MANUAL HARD COPY DISTRIBUTION
DOCUMENT TRANSMITTAL 2004-44057

TRM2 - TECHNICAL REQUIREMENTS MANUAL UNIT 2

Susquehanna SES Unit 2 Cycle 12

CORE OPERATING LIMITS REPORT REVISION DESCRIPTION INDEX

**MCPR OPERATING LIMIT VERSUS CORE POWER
EOC-RPT AND MAIN TURBINE BYPASS OPERABLE
TWO LOOP OPERATION (BOC TO EOC)
FIGURE 5.2-2**

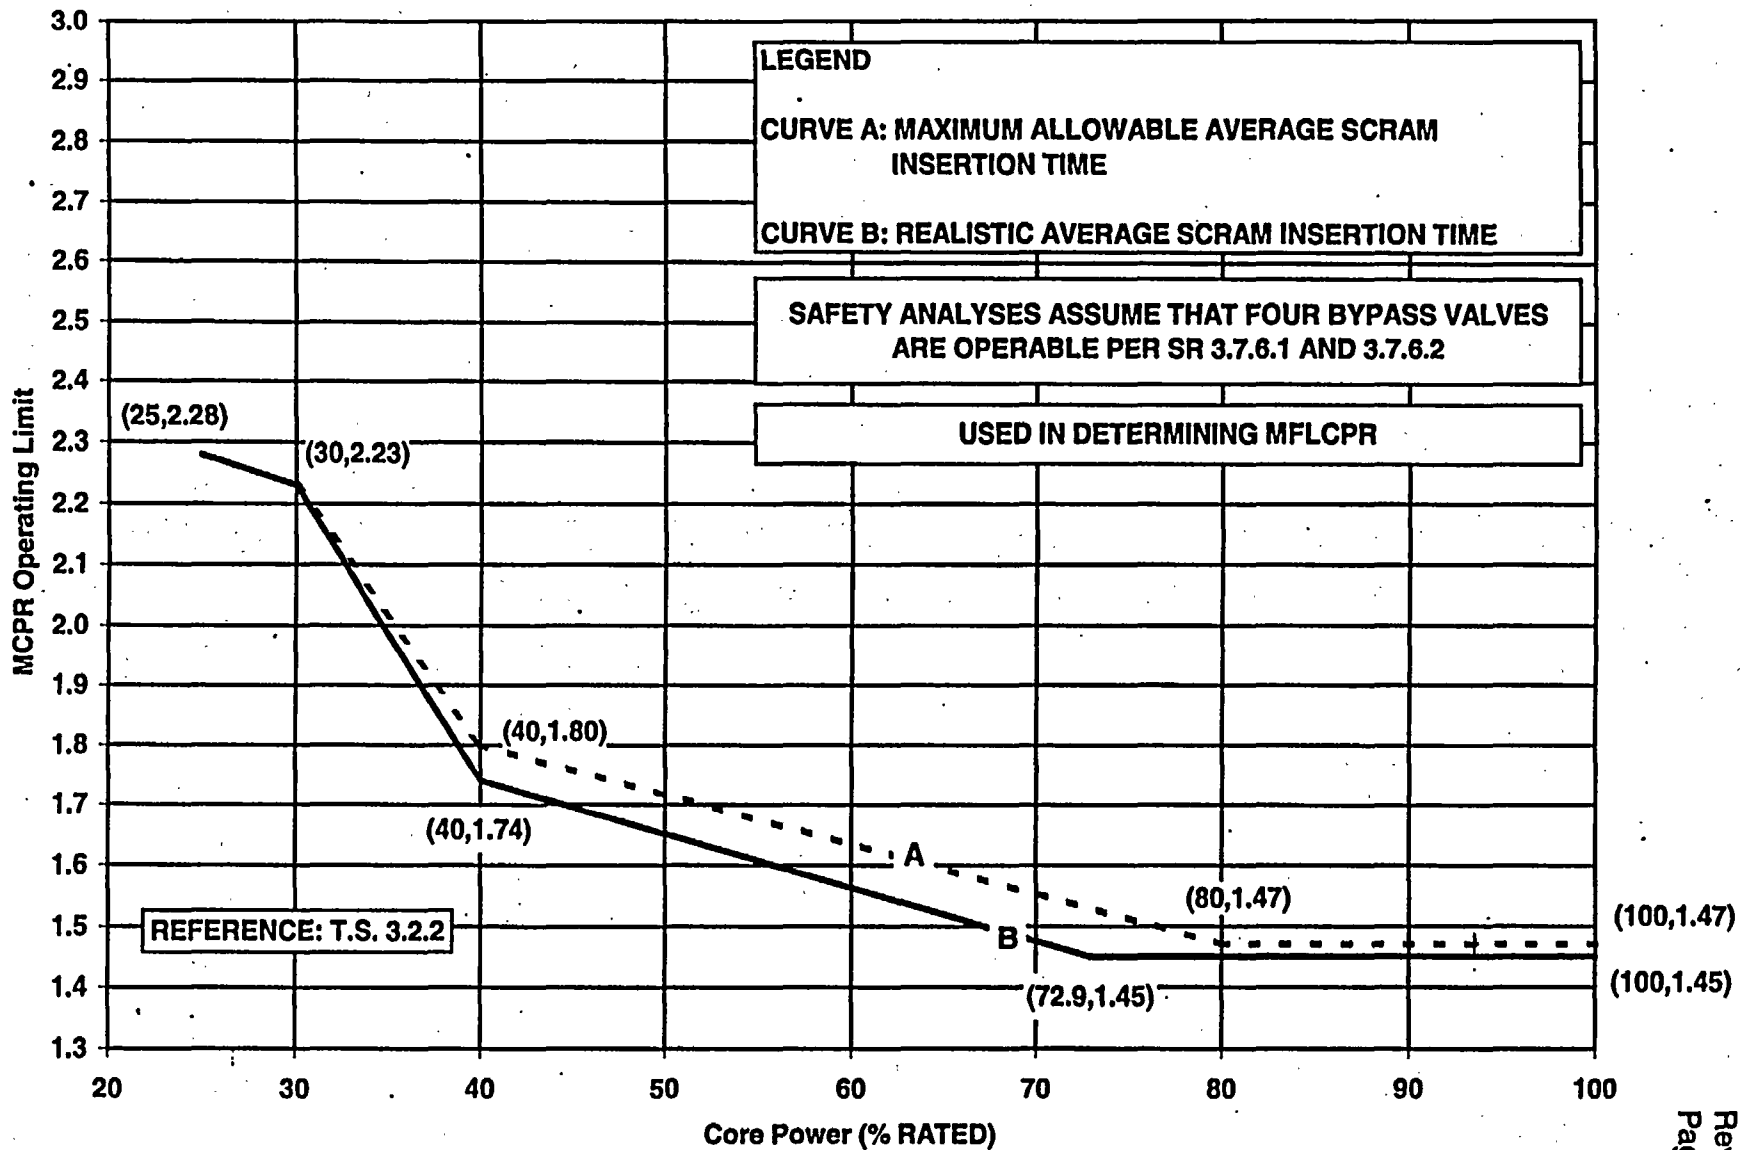
3	5.0 8.0 10.0	<p>The figures within Section 5.0 and Section 8.0 are revised to incorporate the 0.02 MCPR Safety Limit reduction approved by Amendment No. 191.</p> <p>Figure 5.2-2 is revised to correct the Operating Limit error documented by CR 606127.</p>
